Lower Big Thompson Watershed Phase 2 Hydrologic Evaluation

Post September 2013 Flood Event

Response to Review Comments by Jacobs Team

Figure 1

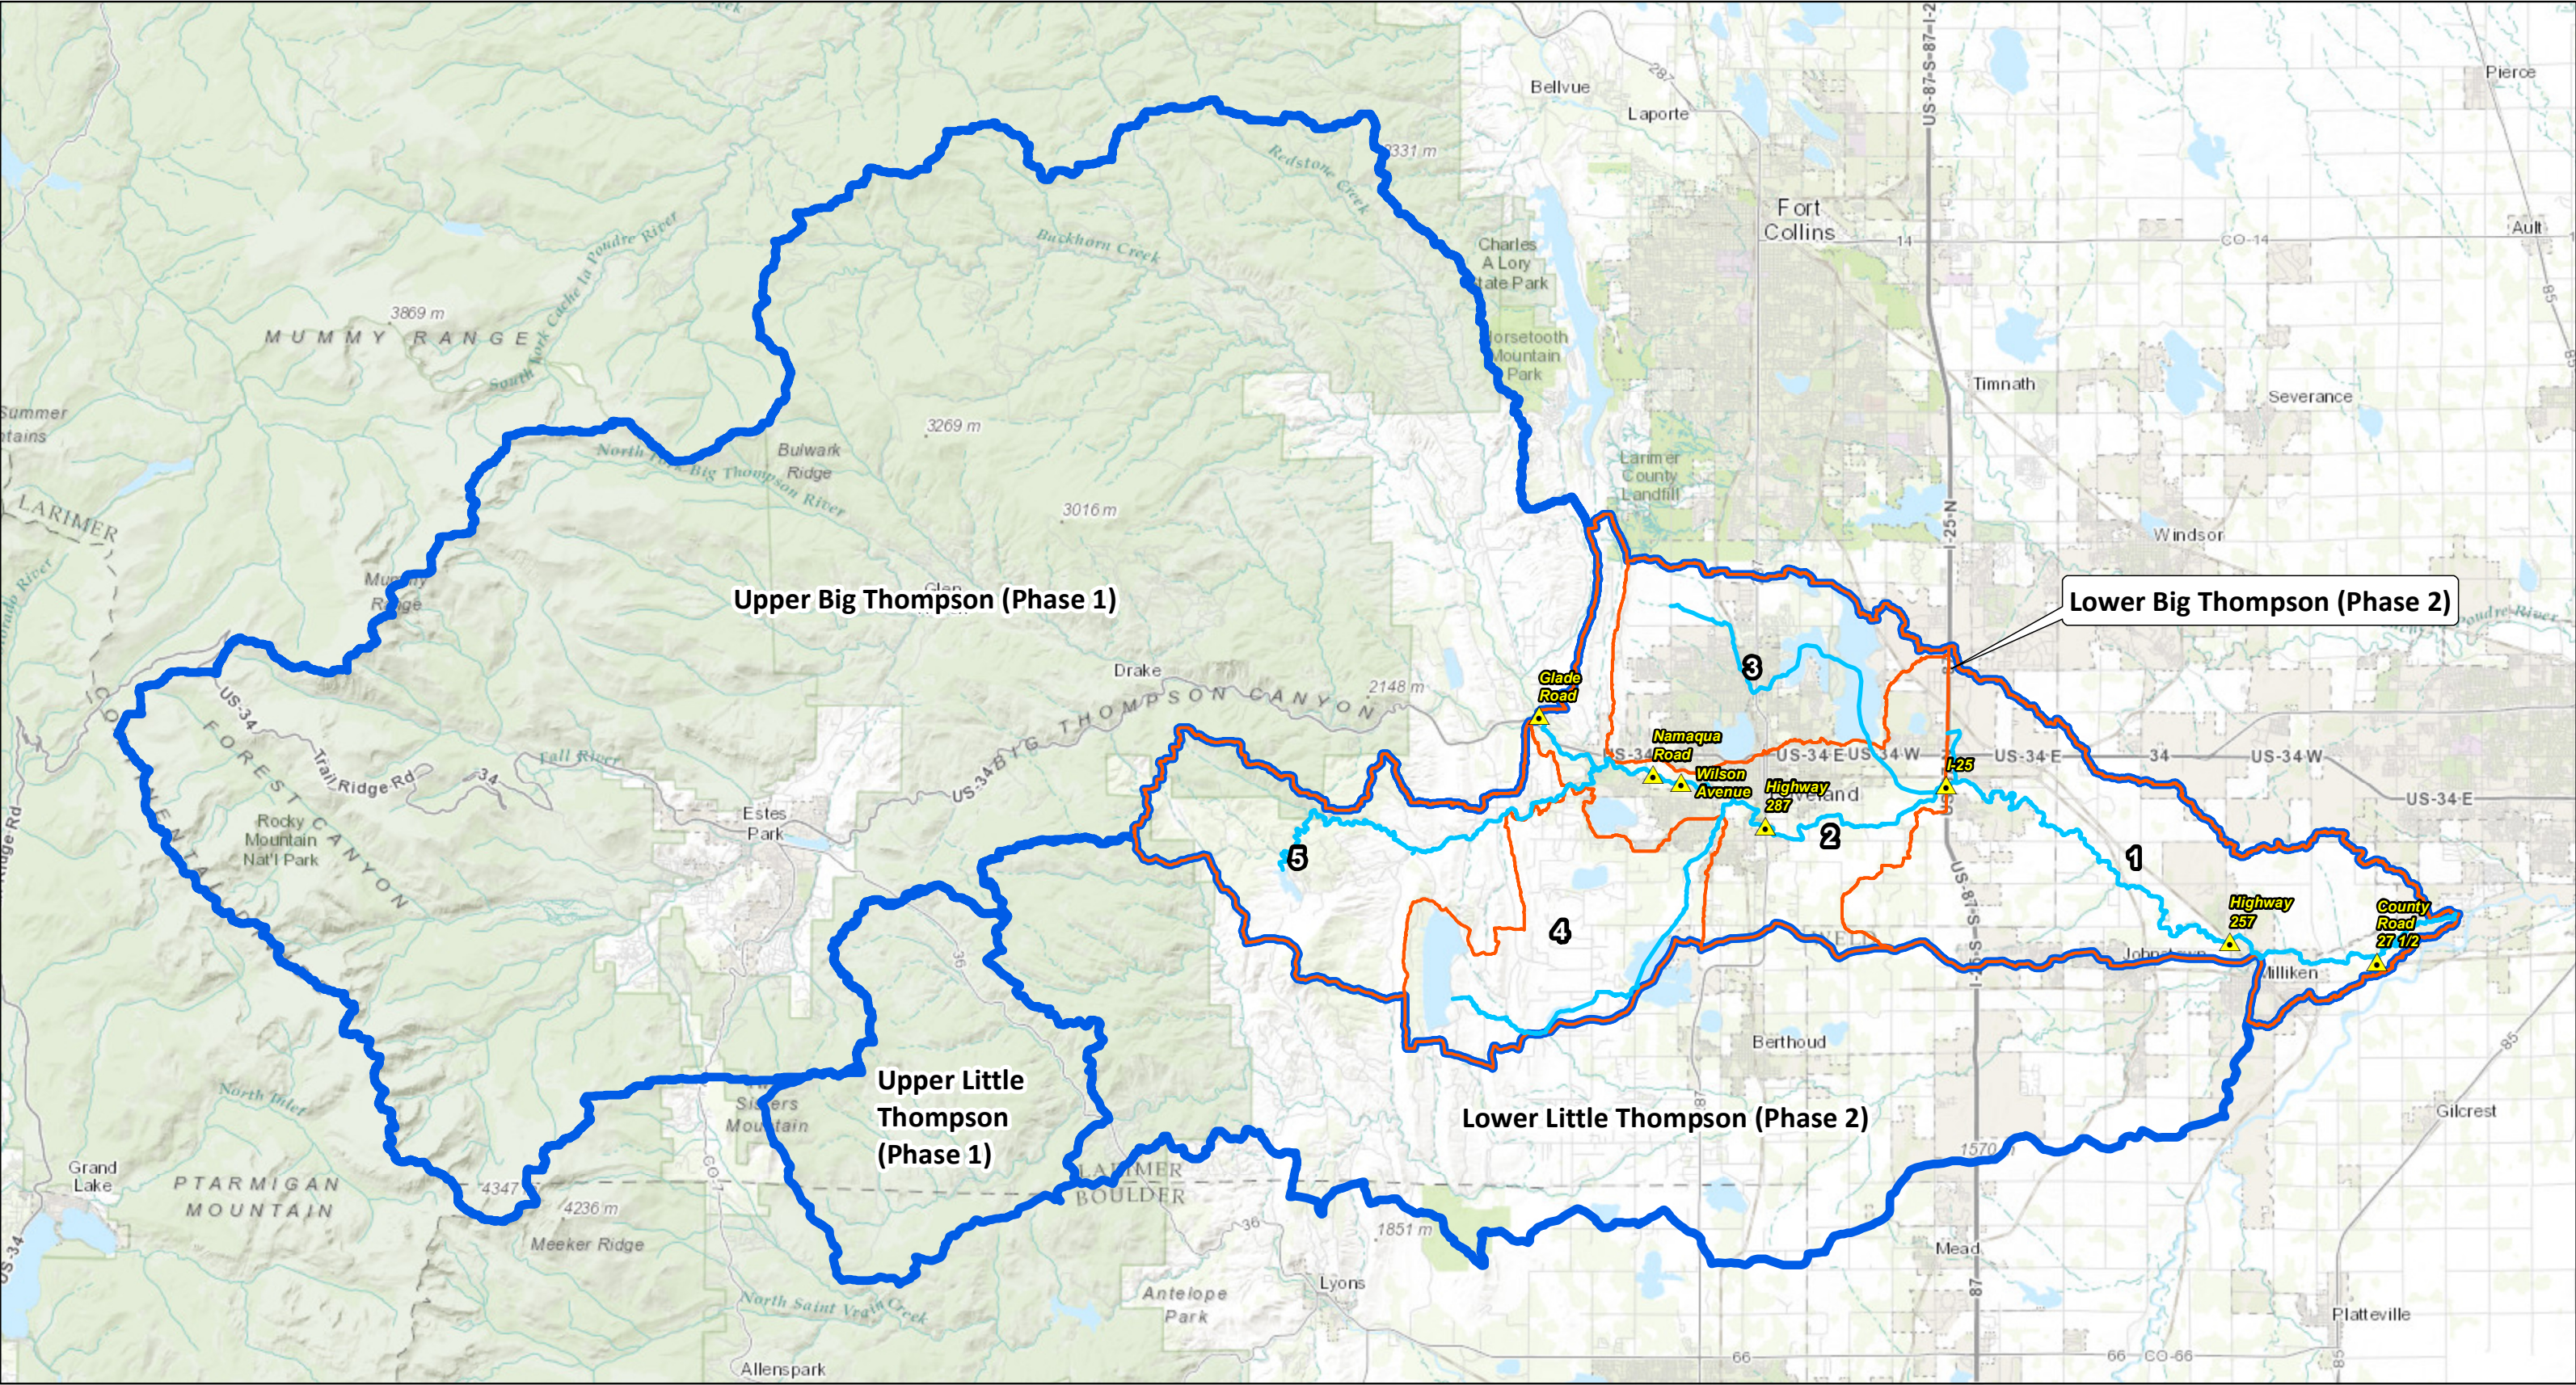
1. The page numbers are off. No page 4, which is supposed to be the Lower Big T study area. That figure is not labeled as Figure 1.

The page numbers have been corrected. The mistake was a result of inserting the figure into the pdf as page 3 instead of page 4 where it was supposed to be. The figure has also been labeled as Figure 1.

Labels have been added to the figures. The figure on page 4 has been labeled "Figure 1" and the figure in Appendix D has been labeled Figure D.1. The blank pages after the figures were
